**BLACK & VEATCH**  
Building a world of difference®

Re: Lee County – DW  
Central Wastewater Treatment Facility  
Application No. FL0021261-020  
Caloosahatchee Basin

We are in receipt of your letter dated September 10, 2010 with your review comments on the wastewater permit application for the above referenced facility. Please consider the following responses to your comments during your further review of the application. We have restated each comment below and included our response in bold, italics.

**Figure 3-1**  
**City of Ft. Myers Central AWWT Facility**  
**Projected AADF and PTMADF**

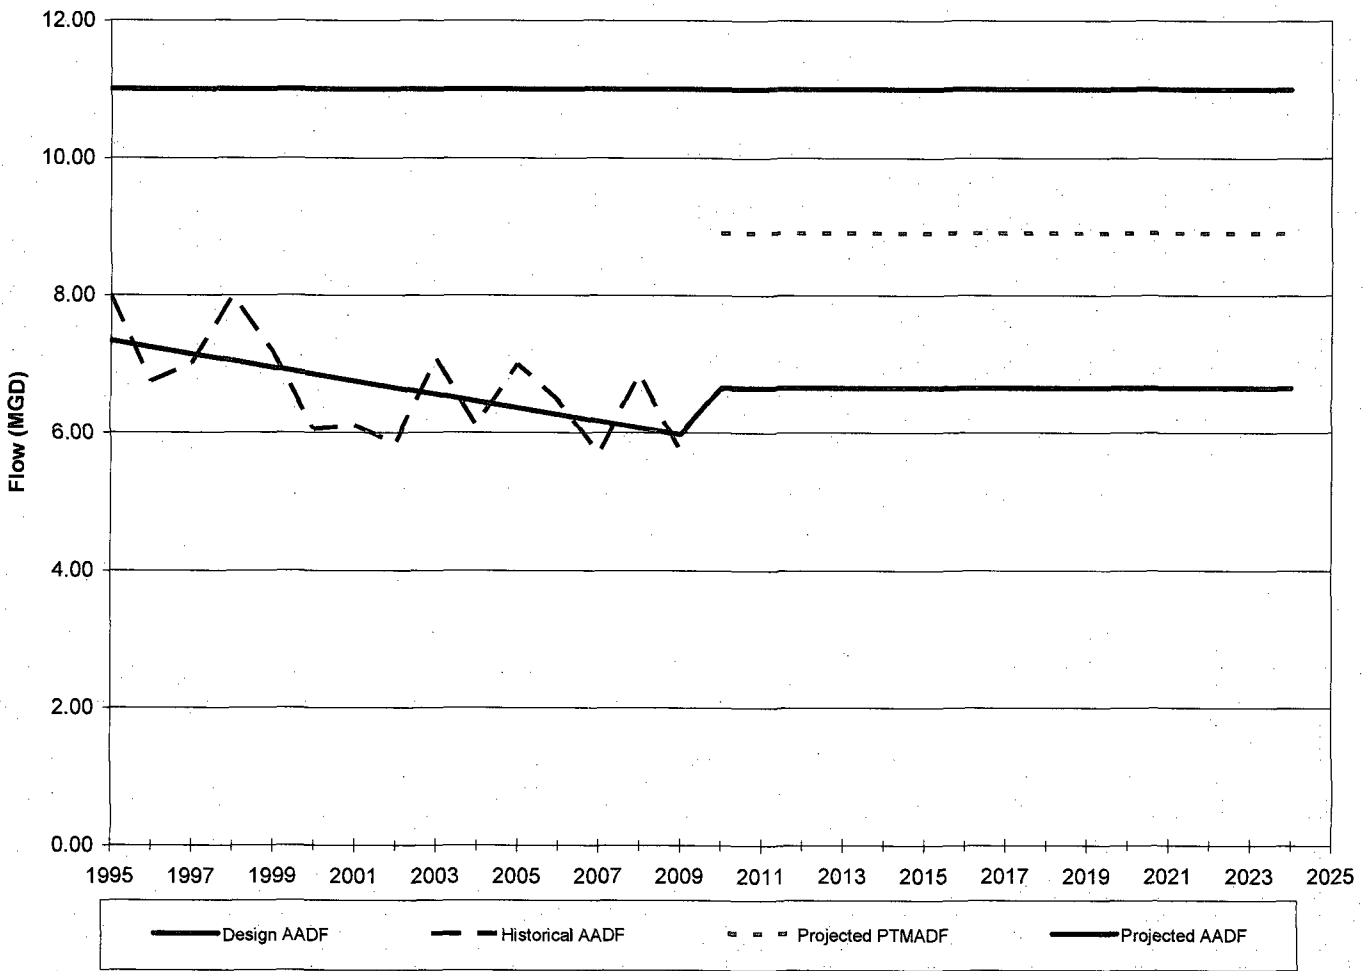
6. Please refer to the Capacity Analysis Report. Please base the projection of future flow on population growth rates and water consumption. [62-600.405(6), FAC]

***The City intends to base load the Central AWWTF with a constant flow and handle future flow increases at the South AWWTF. A revised figure 3-1 is included, as an attachment to this letter, which deletes the future downward projection trend.***
